LUA Bulimba – Other Change Application – 187–193 Oxford Street, Bulimba

1 Introduction

This report has been prepared by Urbis on behalf of Oxford Precinct Pty Ltd in support of an Other Change Application for the approved Lua Bulimba development at 187–193 Oxford Street, Bulimba. The application seeks approval for architectural and functional refinements to the approved rooftop and roof terrace areas, including revised roof terrace layout, wellness and pool facilities, mechanical plant zones, service areas, roof form and associated elevation updates. The proposed changes are shown on the architectural submission package prepared for the project, including proposed roof terrace, rooftop and elevation drawings dated 7 September 2026.

A comparison of the approved and proposed west elevations are provided in Figures 1 and 2 below.

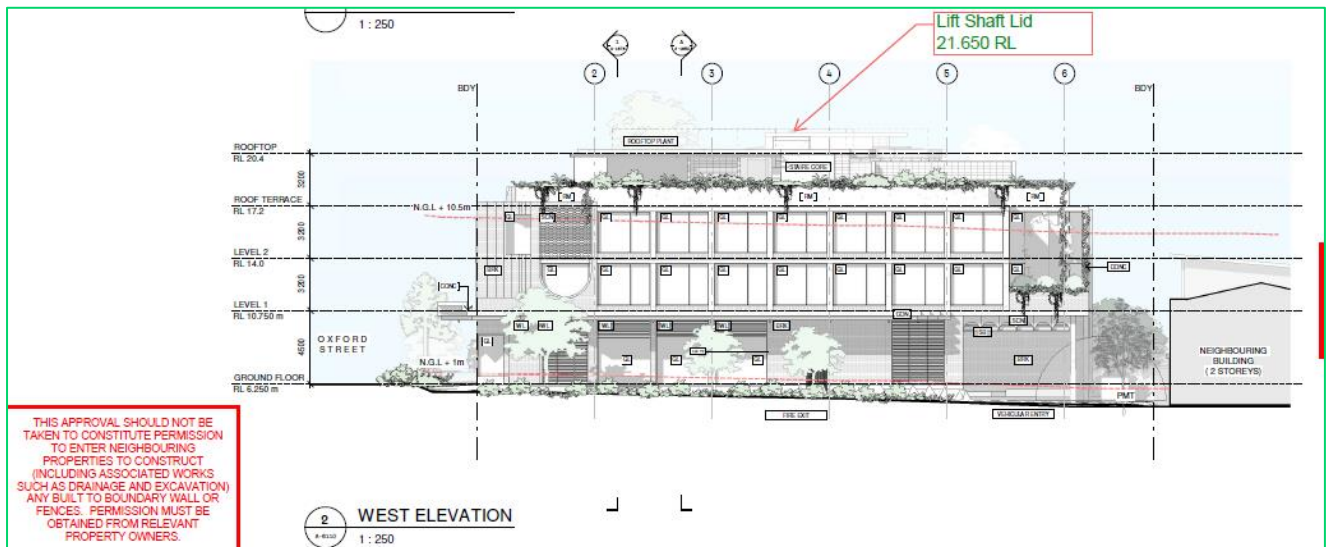
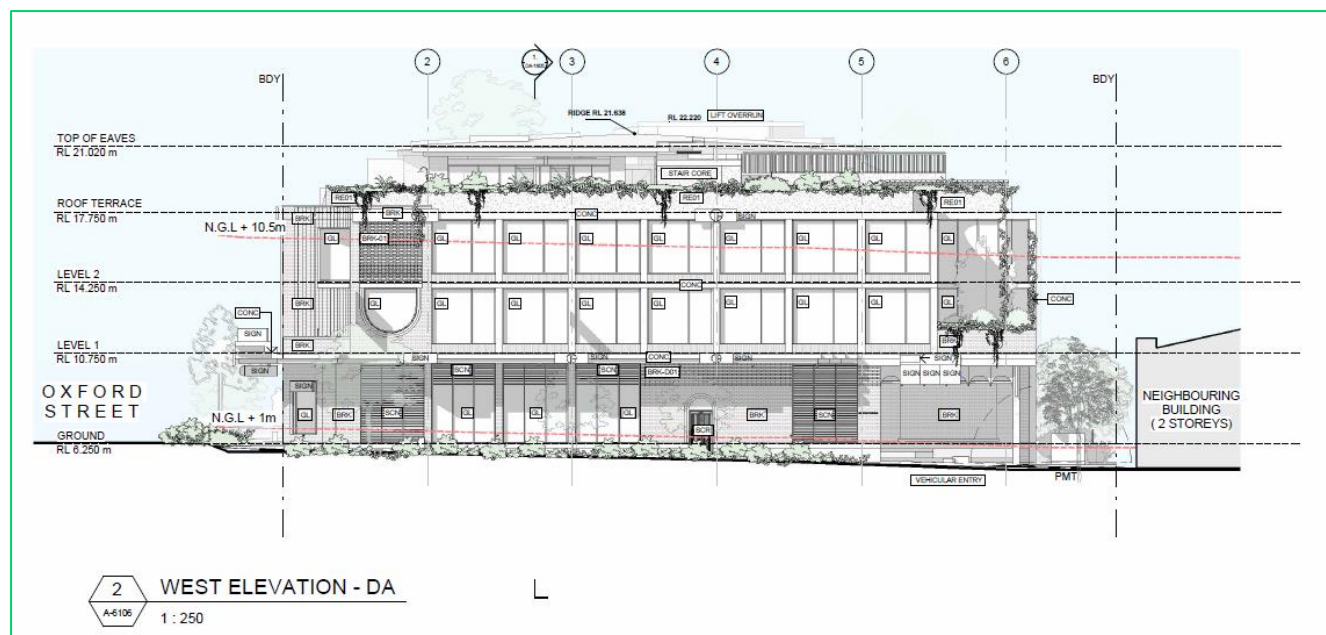
- Reconfigured roof terrace layout, including wellness, recreation and pool facilities.
- Revised male, female and accessible amenities, saunas, steam room and ancillary back-of-house spaces.
- New or amended mechanical, refrigeration, pool pump, sprinkler tank, service corridor and riser zones.
- Refined roof form, including roof planes, gutters, skylight/open-to-above areas, roof ridge and eaves levels.

- Consequential elevation updates to reflect the revised rooftop and terrace design.
- Updated screening, awnings, and material references shown on the proposed elevation drawings.

A-1106

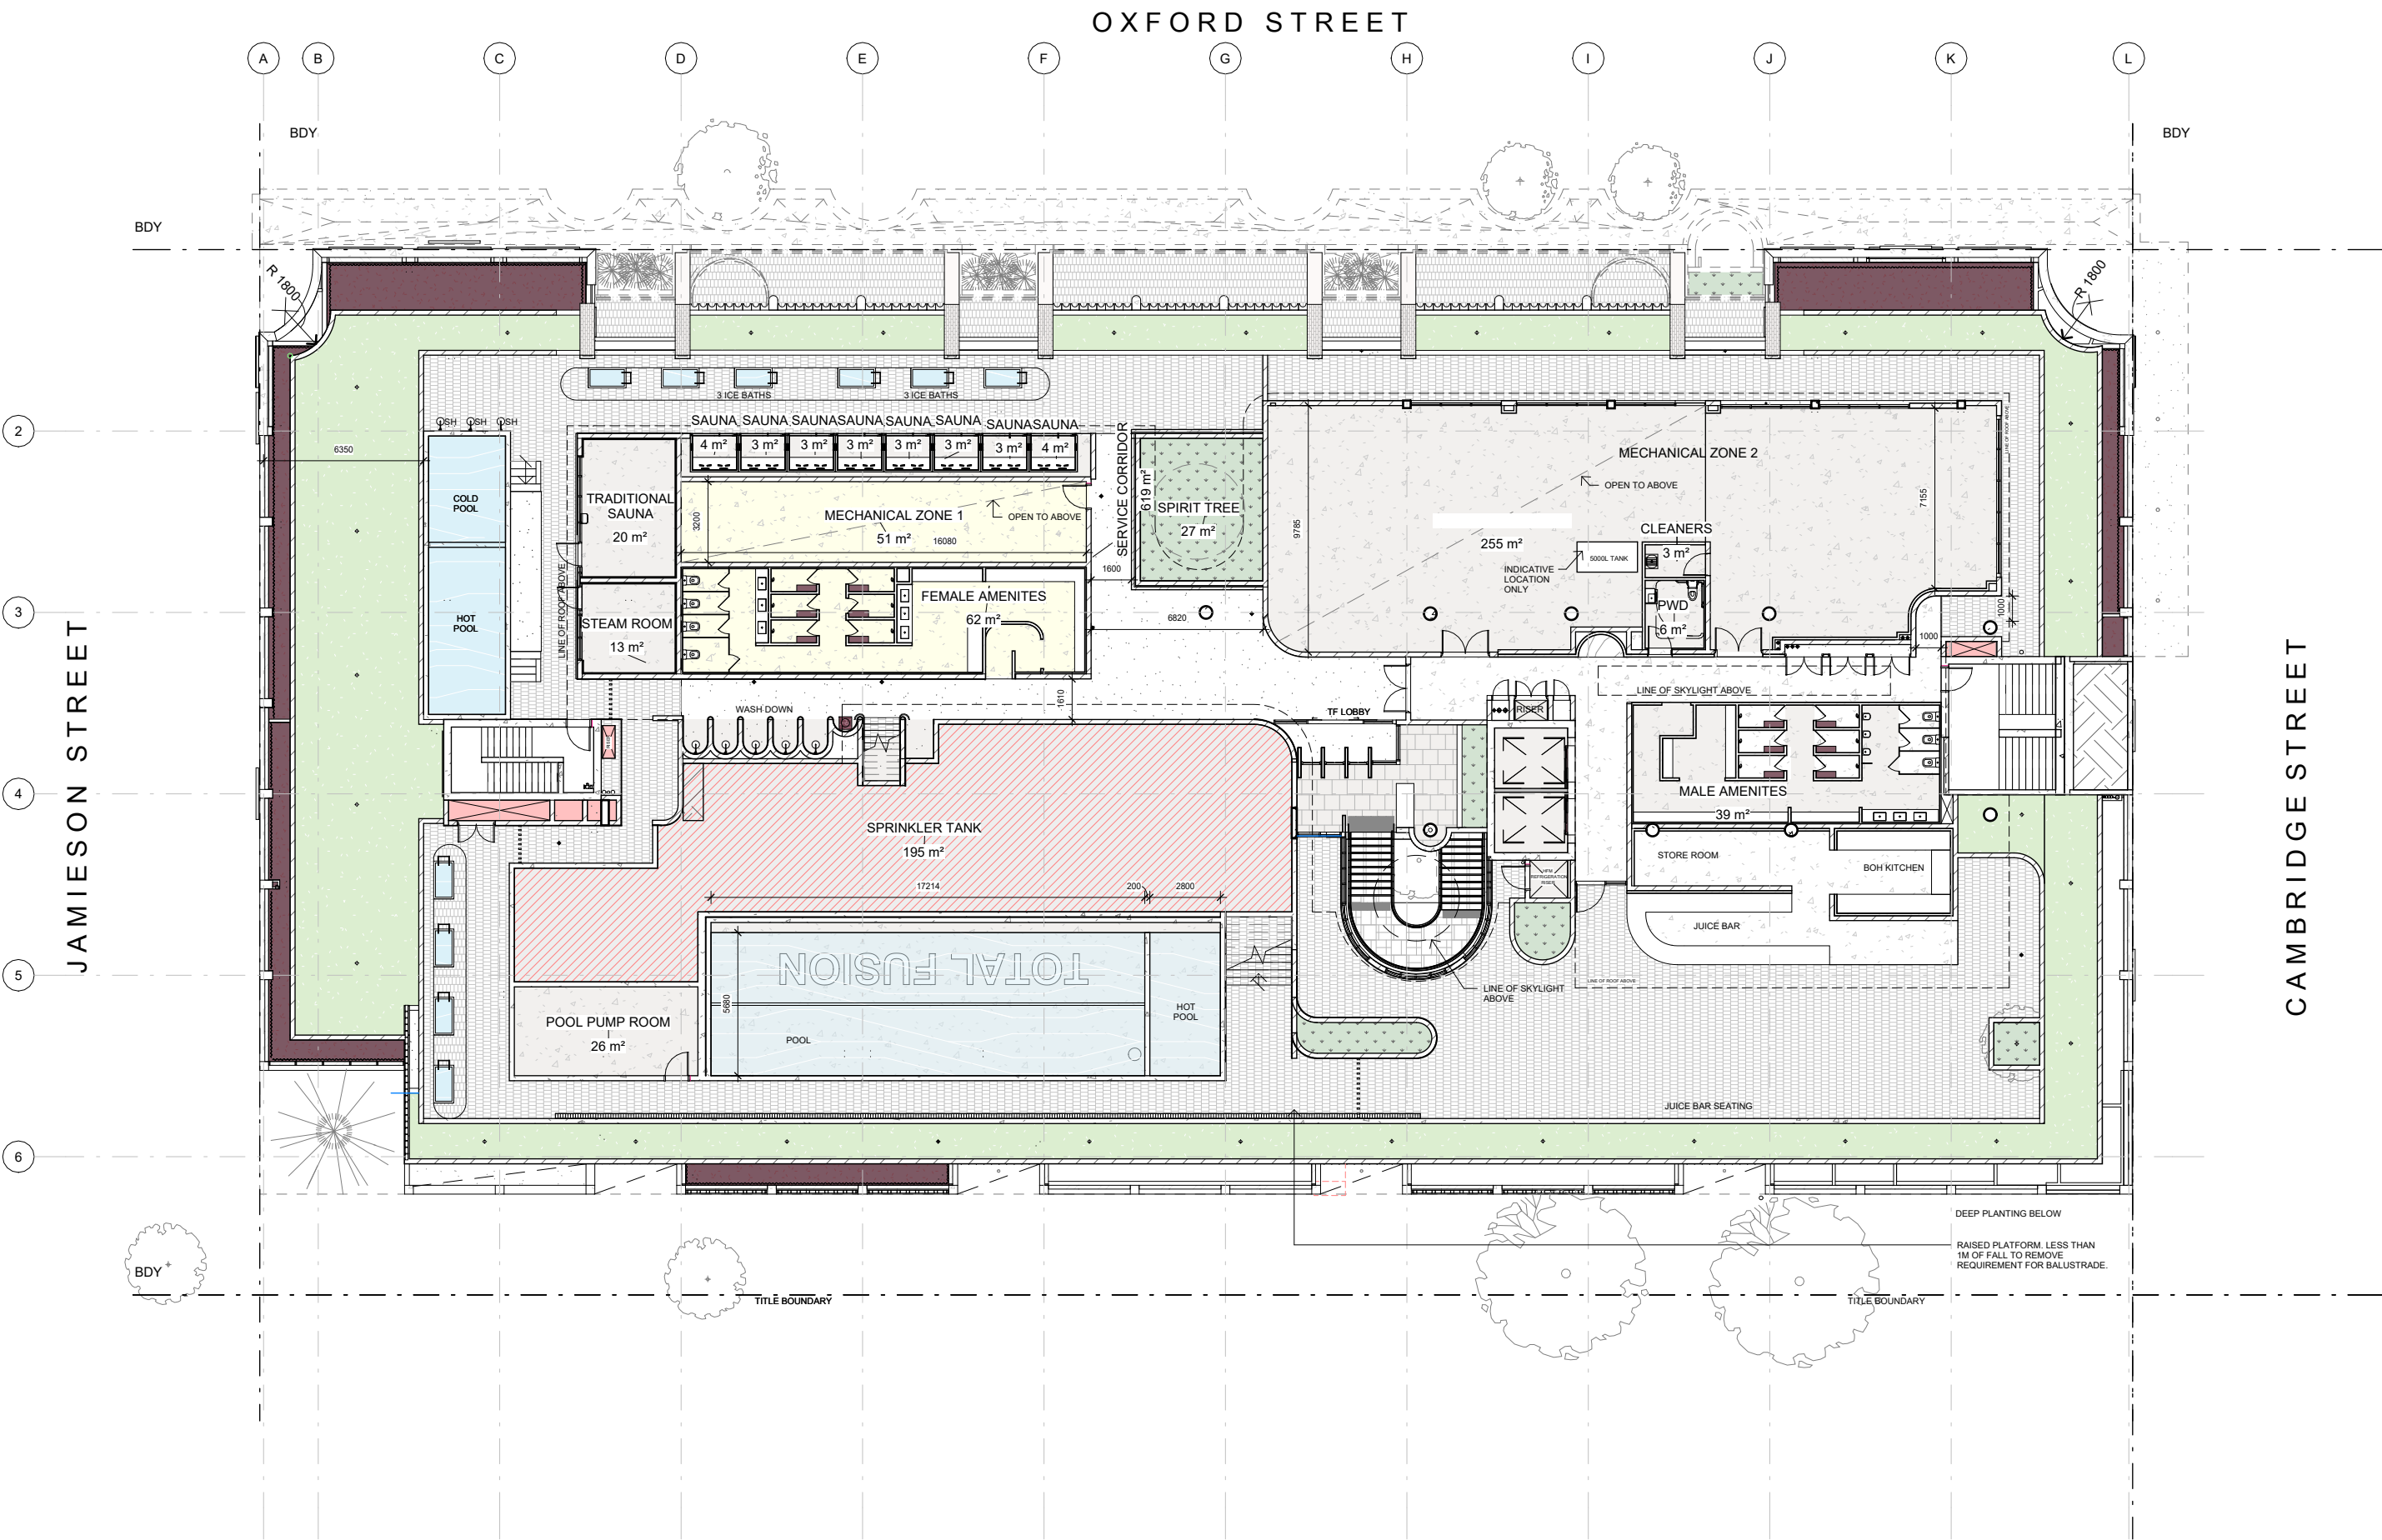
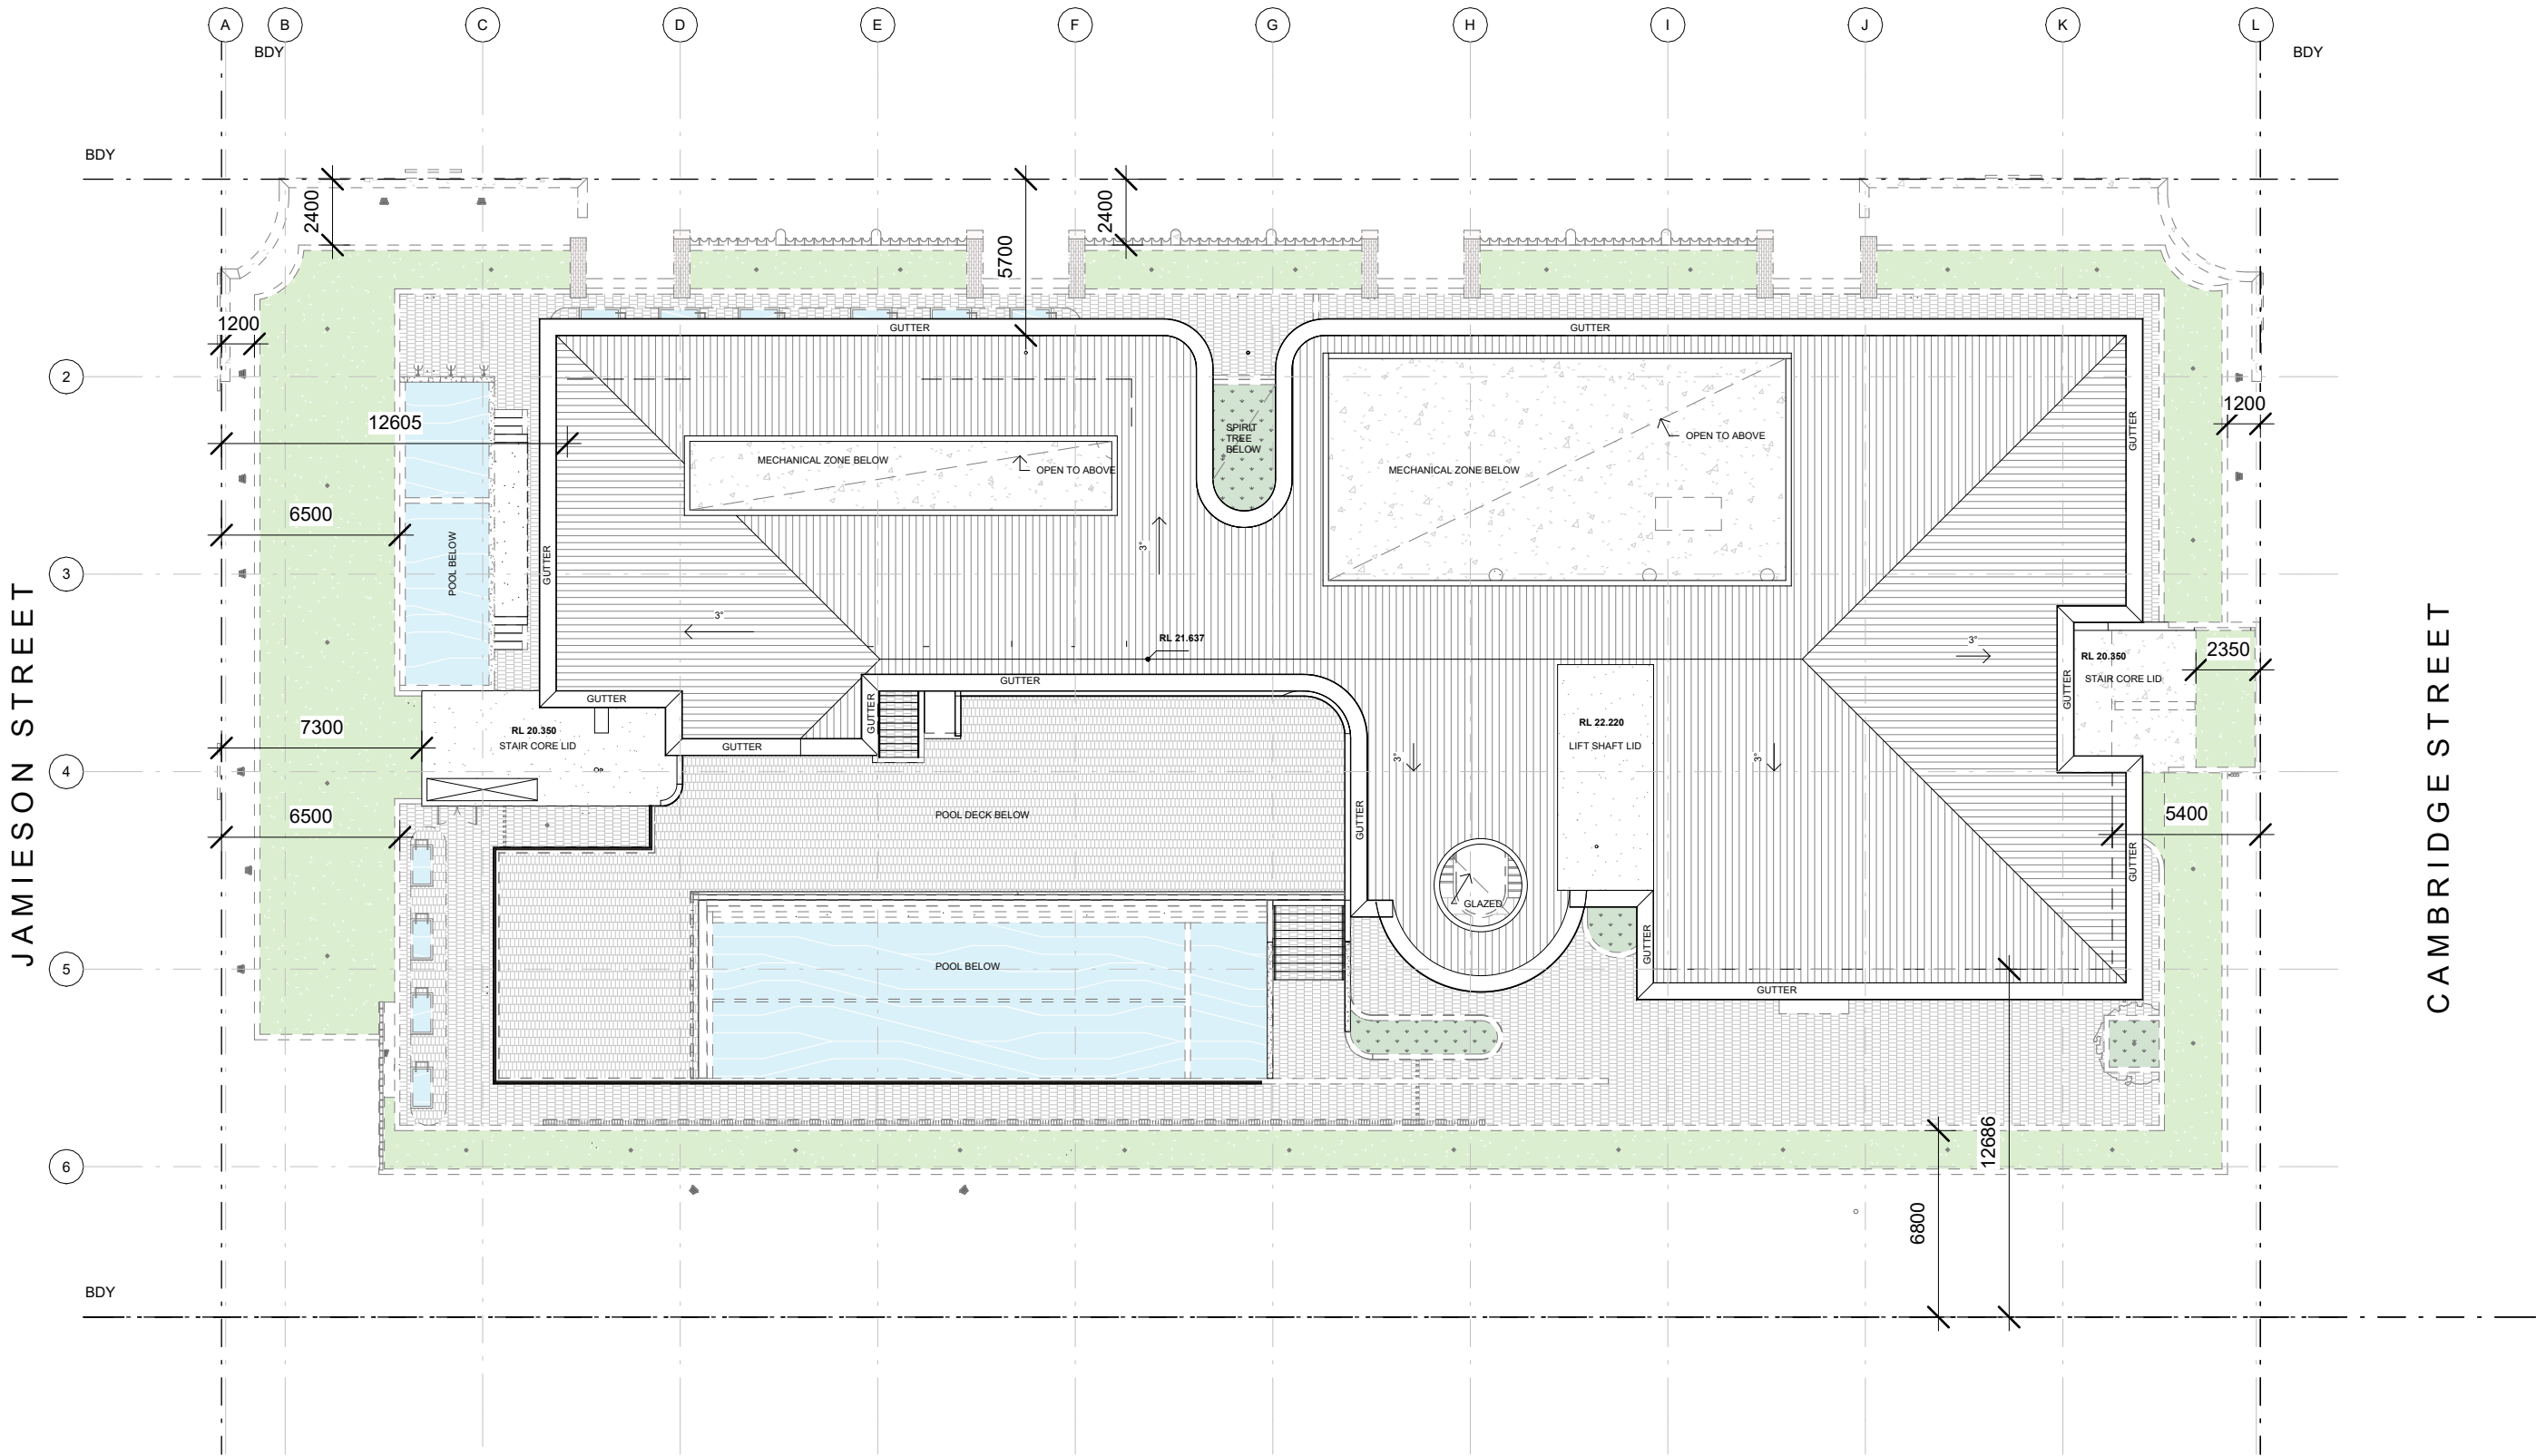
Original approved plan	Proposed updated plan	Key changes
Roof Plan A-1106, Revision 11, dated 17 December 2025. Shows the approved roof terrace layout, including pools, change rooms, studio rooms, saunas, plant access, tenancy areas and roof lines.	Roof Terrace Lower Plan DA-1106, Revision A, dated 7 September 2026. Shows a coordinated wellness layout with hot and cold pools, ice baths, saunas, steam room, amenities, juice bar, seating, back-of-house kitchen, sprinkler tank, pool pump room, risers and mechanical zones.	The proposed plan substantially resolves the roof terrace layout and introduces more detailed wellness, amenity, service and plant areas. The change is principally a layout and operational coordination refinement within the approved rooftop recreation/wellness concept.
Rooftop A-1108, Revision 10, dated 17 December 2025. Shows the approved rooftop arrangement, including plant zones, condenser plant spatial provisions, riser provisions, rooftop plant, accessway, future solar panel allowance and rooftop level references.	Roof Top DA-1108, dated 2 September 2026. Shows a refined roof form with roof planes, gutters, open areas, glazed areas, lift and stair core lids, pool deck below, and mechanical zones below.	The proposed plan rationalises the rooftop into a more coordinated roofscape and identifies the relationship between roof form, terrace uses and mechanical/service zones.
